## Proposed Milton Quarry East Extension JART COMMENT SUMMARY TABLE – Groundwater Modelling

Please accept the following as feedback from the Milton Quarry Joint Agency Review Team (JART). Fully addressing each comment below will help expedite the potential for resolutions of the consolidated JART objections and individual agency objections. **Additional, new comments may be provided once a response has been prepared to the comments raised below and additional information provided.**

|   | JART Comments (May 2022)   | Reference | Source of Comment                   | Applicant Response 2022   | JART Response    |
|---|--|-----------|-------------------------------------|---|------------------|
| <b>Report/Date:</b> Geology and Water Resources Assessment Report December 2021<br><b>Author:</b> GHD |  |           |                                     |   |                  |

### Change calculation #1

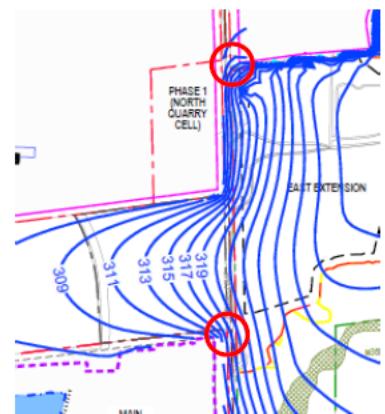
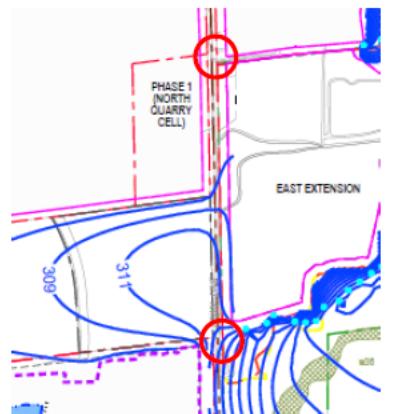
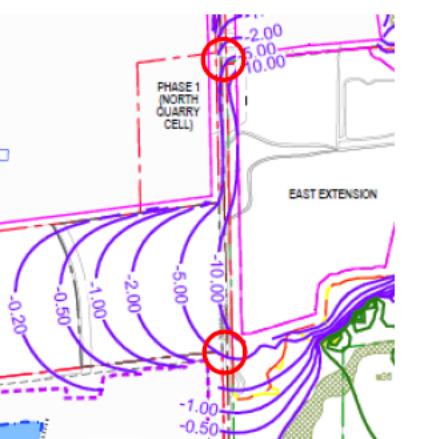
| 8. | <p>Referring to Figures 7.3 and 7.6, are we correct in understanding that the changes are calculated as follows? As shown in the two slides attached to this letter, it is not obvious from spot checks that this is how the results are calculated.</p> <p><u>Figure 7.3</u><br/>Change = Simulated Layer 3 water levels for the approved existing quarry fully extracted - Simulated Layer 3 water levels for the approved existing quarry + MQEE fully extracted</p> <p><u>Figure F7.6</u><br/>Change = Simulated Layer 3 water levels for the approved existing quarry rehabilitation - Simulated Layer 3 water levels for the approved existing quarry + MQEE rehabilitation</p>   | Page F9 | S.S. Papadopoulos & Associates Inc. | <p>The changes are calculated opposite to your understanding. The change is calculated as described below for Figures F7.3 and F7.6</p> <p><u>Figure F7.3</u><br/>Change = Simulated Layer 3 water levels for the approved existing quarry + MQEE fully extracted - Simulated Layer 3 water levels for the approved existing quarry fully extracted</p> <p><u>Figure F7.6</u><br/>Change = (Simulated Layer 3 water levels for the approved existing quarry + MQEE rehabilitation) – (Simulated Layer 3 water levels for the approved existing quarry rehabilitation)</p> <p>See response to the two attached slides below to clarify the calculations.</p>  | <b>RESOLVED.</b>  |

Upper point: 307 masl - ? = 5.0 m

Lower point: 319 masl – 311 masl = 5.0 m (?)

| 12. | <b>Appendix – Change calculations</b><br><br>Change calculation #1  |         |                                     | The values selected in the comment for change calculation #1 are incorrect due to approximating head values from the coarsely spaced contours on Figures F7.1, F7.2, and F7.3. Please see appended Figures 4, 5, and 6 showing more finely spaced contours to clarify the calculation. Figures 4, 5, and 6 correspond to a zoomed in view around the East Extension for Figures F7.1, F7.2, and F7.3, respectively.  | <b>RESOLVED.</b><br>The appended Figures 4, 5 and 6 are added to the project documentation.  |

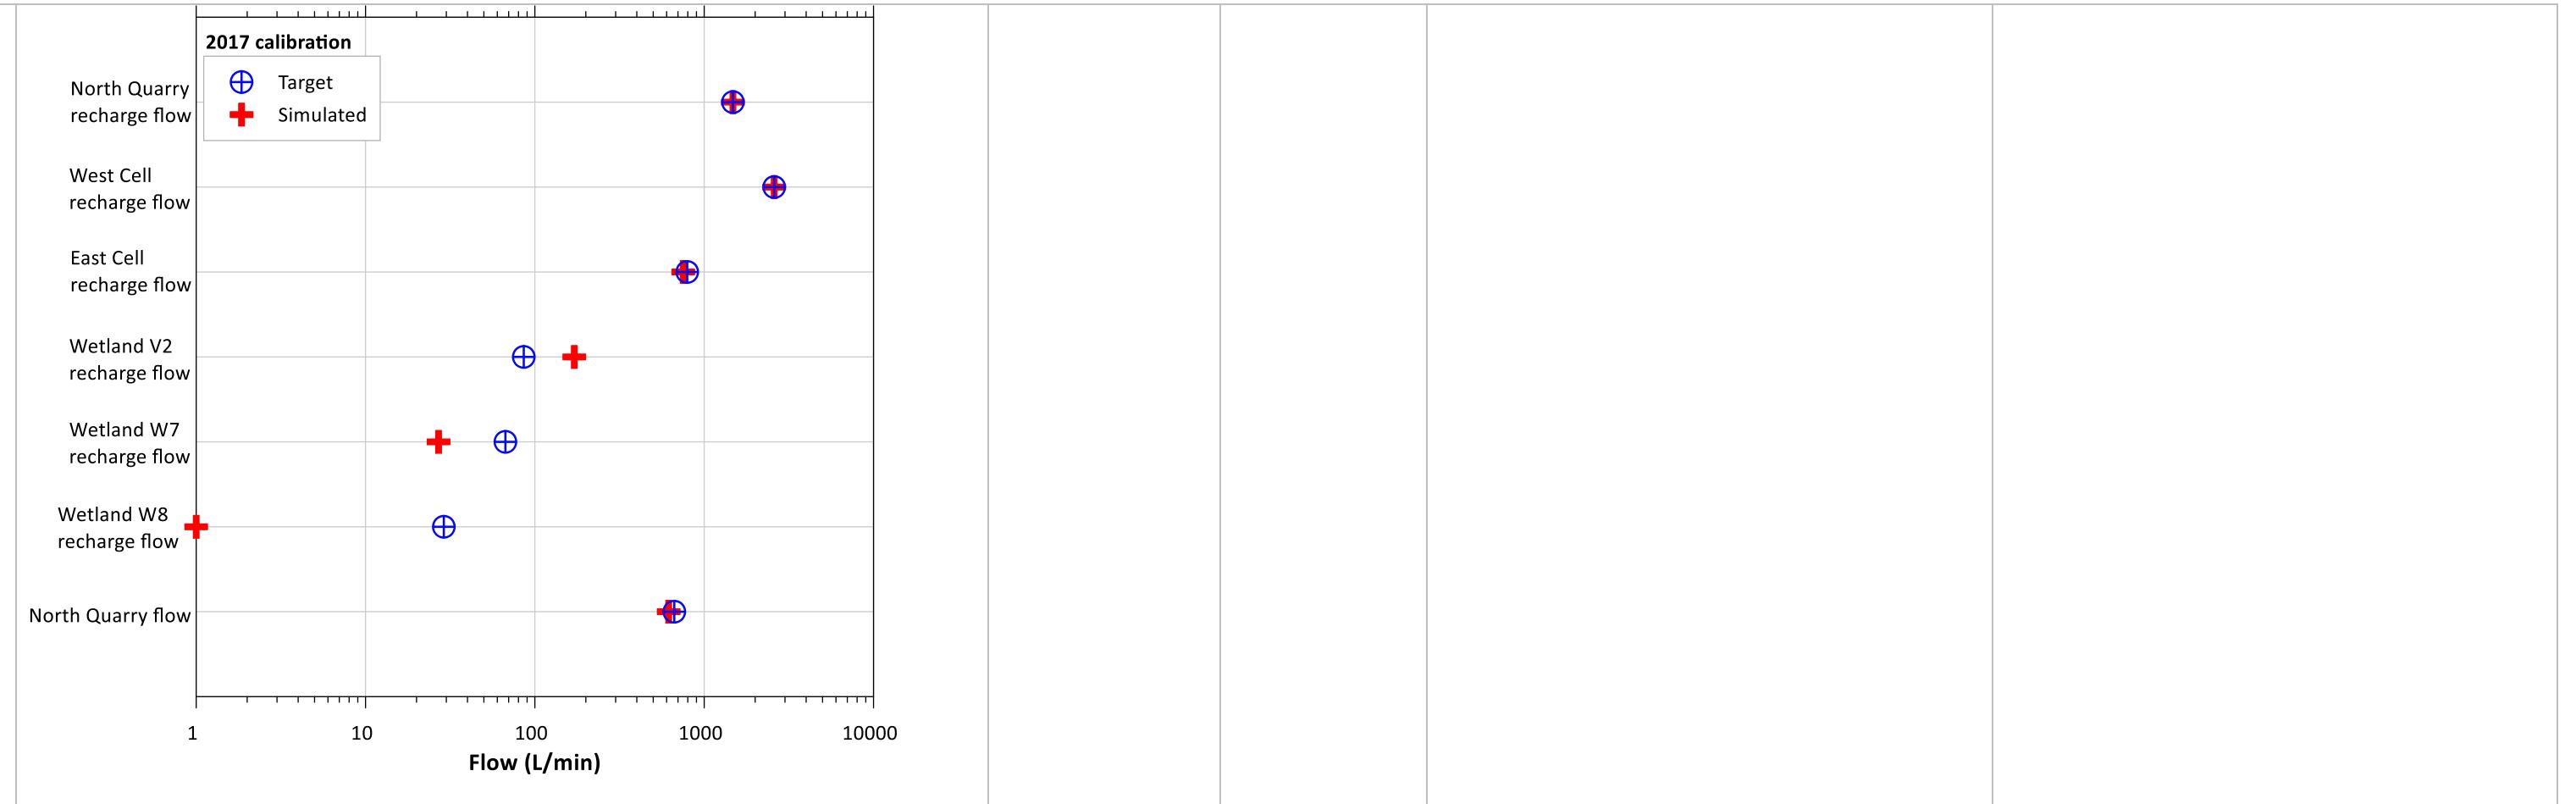
|   | JART Comments (December, 2022)  | Reference | Source of Comment                   | Applicant Response | JART Response      |
|---|---|-----------|-------------------------------------|--------------------|--------------------|
| 22.   | A comparison of the flows reported on Table F6.3 suggests a close match to the three flow targets reported for July 2010. The corresponding results for average 2017 conditions are shown in the plot below. In contrast to the results for 2010, in our opinion the matches to the flow targets for 2017 average conditions are problematic. First, the reported simulated recharge flows for the North Quarry and the West Cell are identical to four significant figures. This strikes us as implausible. Are we missing something fundamental in the comparison? Second, the simulated wetland recharge flows differ substantially from the observed flows. Are time series of recharge flows available to assess whether the simulated values are within the ranges of the observations? | Page F9   | S.S. Papadopoulos & Associates Inc. |                    |                    |
